RE: VGT Phase I SUP Application #2009-01P

Re: Village at Grand Traverse – Phase 1 Site Plan – 3rd Review
OHM Job No. 0237-09-0030

VILLAGE OF GRAND TRAVERSE, L.L.C.
THE VILLAGE AT GRAND TRAVERSE PHASE I
 OVERALL PHASE I SITE PLAN - P.C. PH I RECOMMENDATION SUBMISSION
 SECTION 2, TOWN 27 NORTH, RANGE 10 WEST
 ACME TOWNSHIP, GRAND TRAVERSE COUNTY, MICHIGAN

VILLAGE OF GRAND TRAVERSE, L.L.C.
THE VILLAGE AT GRAND TRAVERSE PHASE I
PHASE I CORRIDOR PLAN - P.C. - PH I RECOMMENDATION SUBMISSION
 SECTION 2, TOWN 27 NORTH, RANGE 10 WEST
 ACME TOWNSHIP, GRAND TRAVERSE COUNTY, MICHIGAN

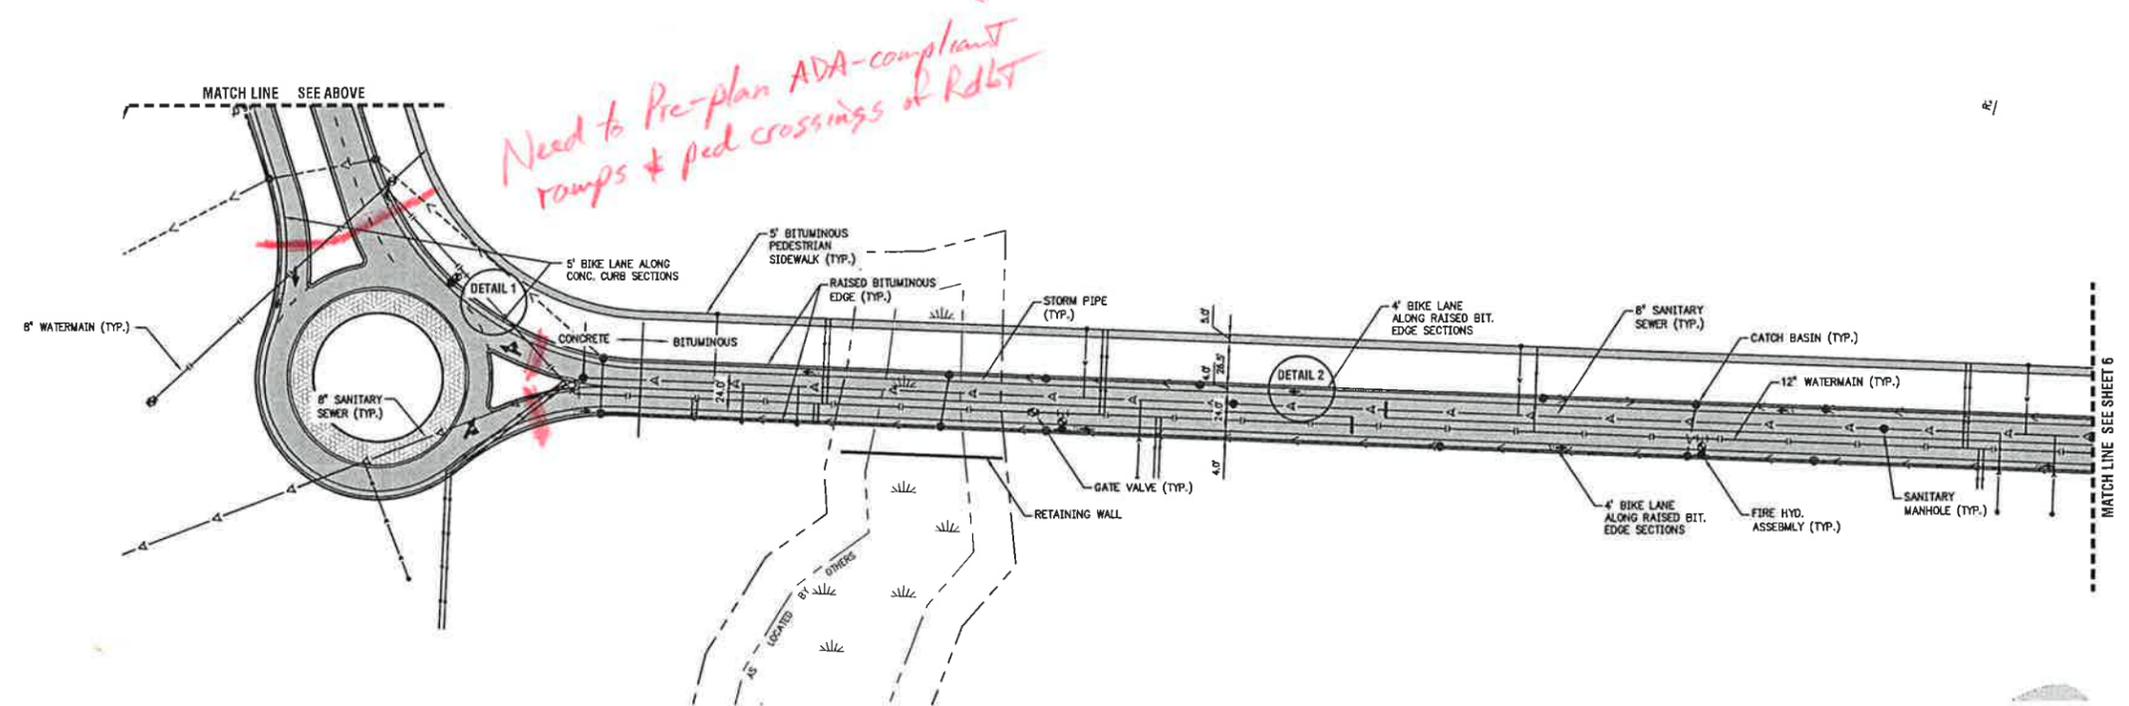
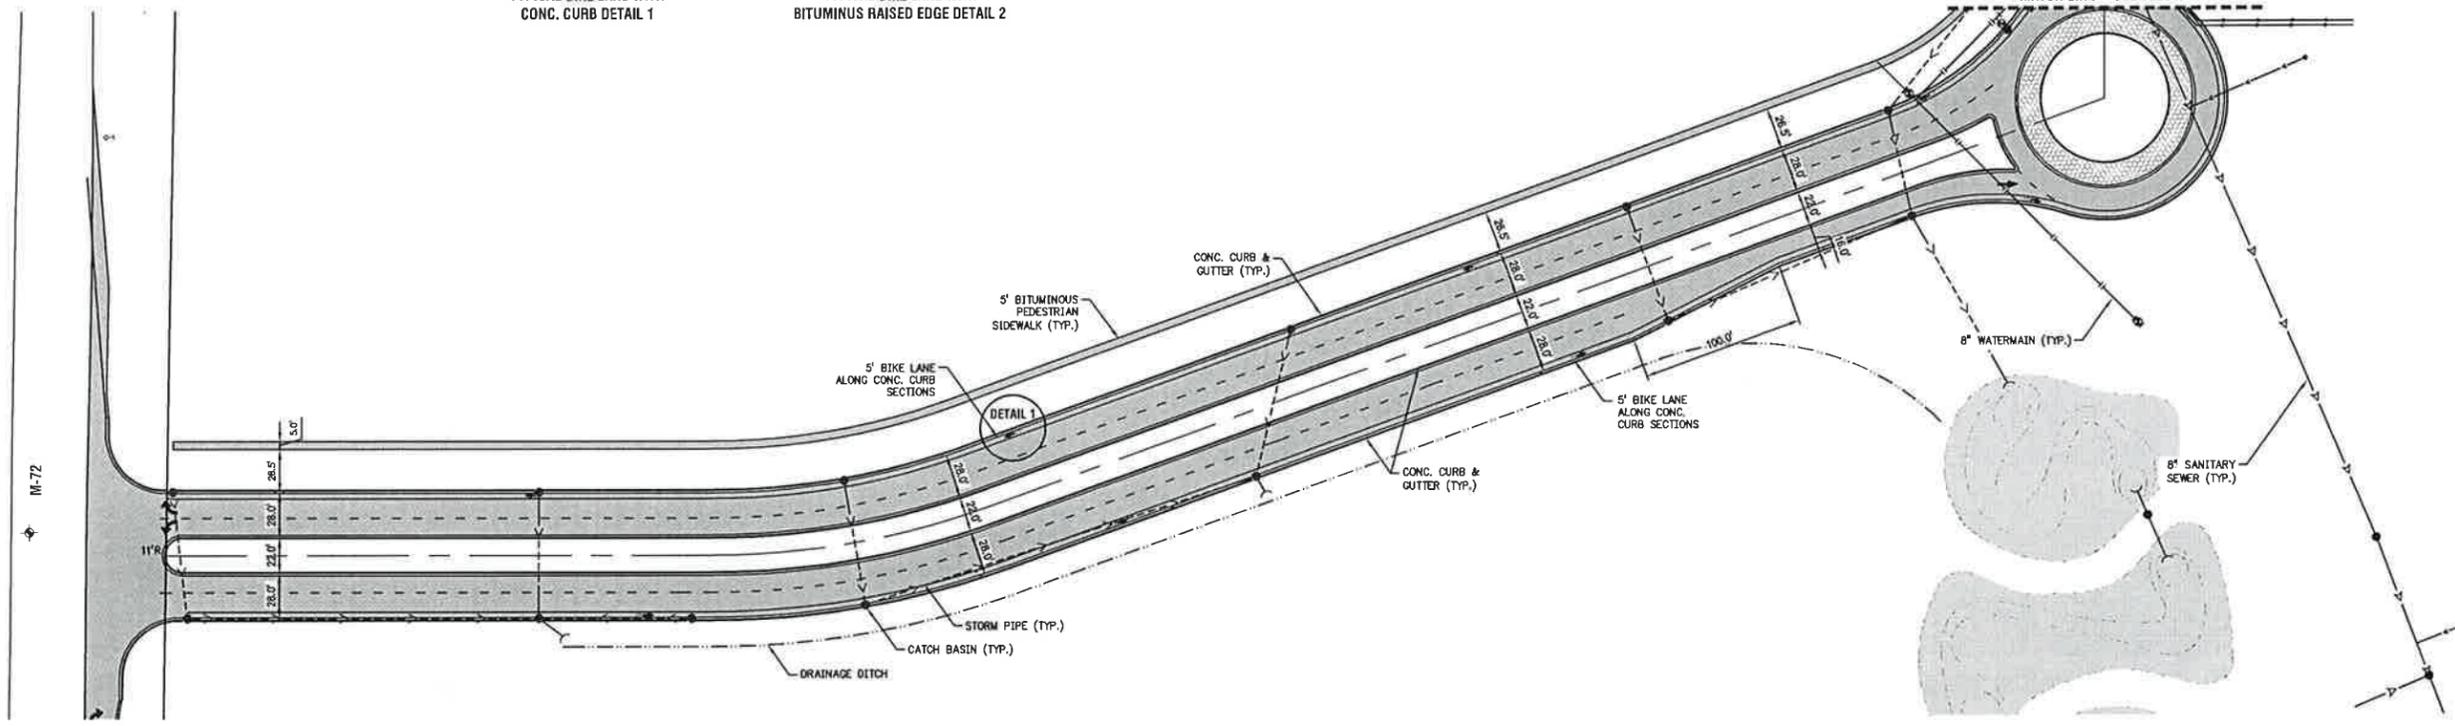
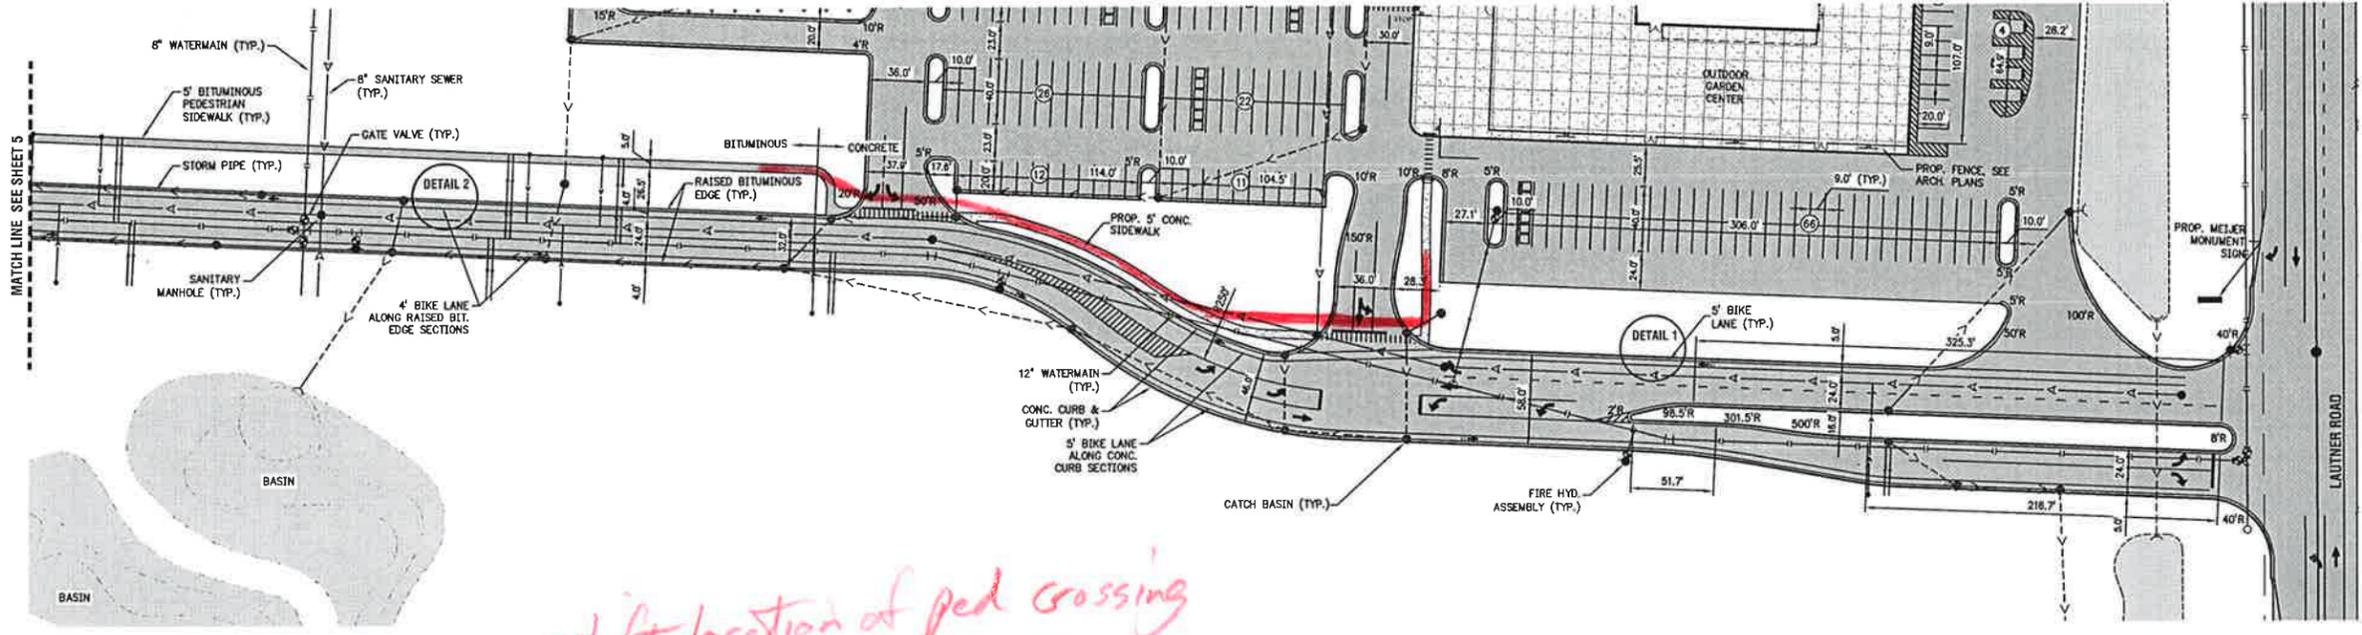
- ▼ The sidewalk crossings on the Meijer driveways to the E/W Main Corridor are positioned to be very close to the travel way of the Main Corridor, well within the curb returns of the driveways. This is very poor design for pedestrians, maximizing their crossing distance and time of exposure to cross traffic. The sidewalk and related driveway crossings should be further removed from the traveled way, closer to the spring points of the curb returns.

- ▼ There should be a sidewalk along the north side of Drive No. 5 from Meijers internal drive to Lautner Rd.
- ▼ The east Meijer driveway uses a 3-lane approach with the unconventional arrangement of the center lane for joint left turns and straight movements. At a minimum, this driveway needs to be reworked to the more traditional arrangement of the center lane exclusive for left turns and the curb lane for through and right turns. This impacts the alignment of the future driveway for the parking areas to the south of Drive No.5.

Need to Pre-plan ADA-compliant ramps & ped crossings at Rd&T

*Shift location of ped crossing
away from intersections*

VILLAGE OF GRAND TRAVERSE, L.L.C.
THE VILLAGE AT GRAND TRAVERSE PHASE I
PHASE I M-72 LANDSCAPE PLAN - P.C. PH I RECOMMENDATION SUBMISSION
SECTION 2, TOWN 27 NORTH, RANGE 10 WEST
ACME TOWNSHIP, GRAND TRAVERSE COUNTY, MICHIGAN

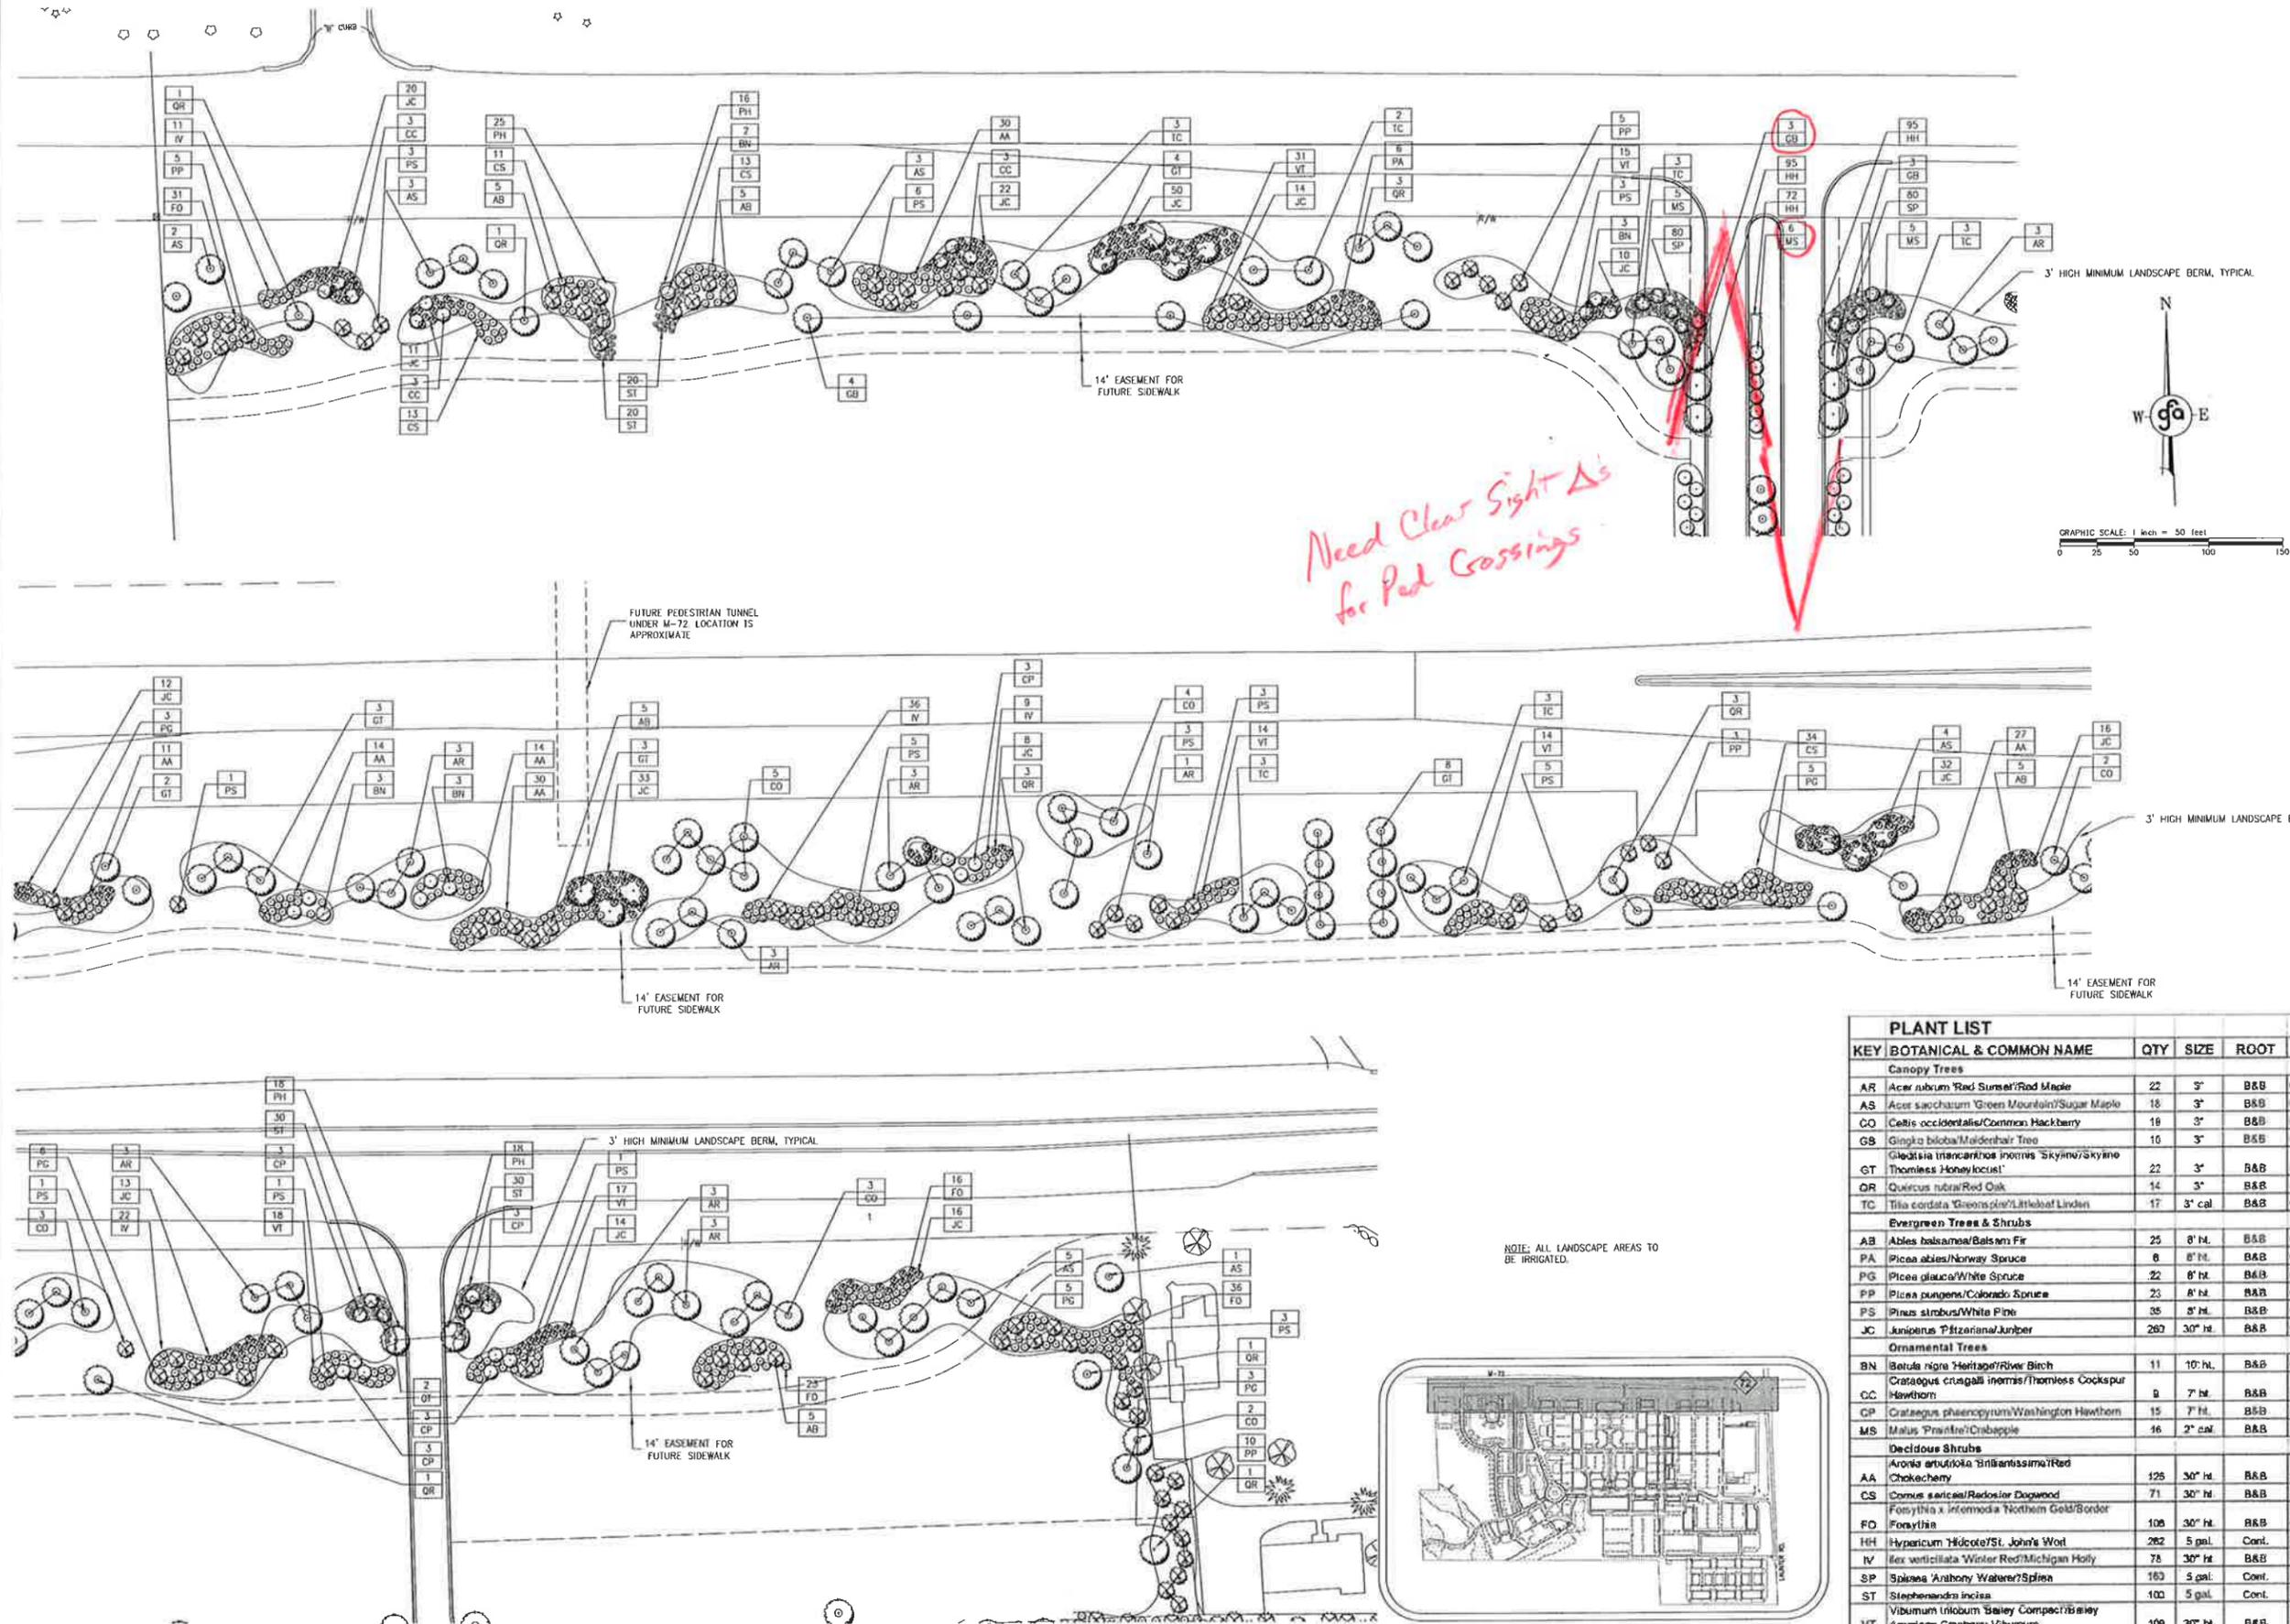
- ▼ Intersection sight distance triangles should be imposed at the junctions of all streets, driveways and circulation aisles, to assist in verifying that proposed berms and plantings will not pose safety concerns.

- ▼ Need to revise the plans to ensure a clear sight distance triangle to the future sidewalk crossings for the proposed walk along M-72 and Lautner. This applies to Drives No. 2, 4 & 5 for Phase 1.

- ▼ Trees and other substantial landscaping are being shown planted within the easement for future sidewalk, especially along Lautner Rd. These plantings should be relocated; keep the sidewalk easements clear of landscaping.

Need Clear Sight Tri for Ped Crossings
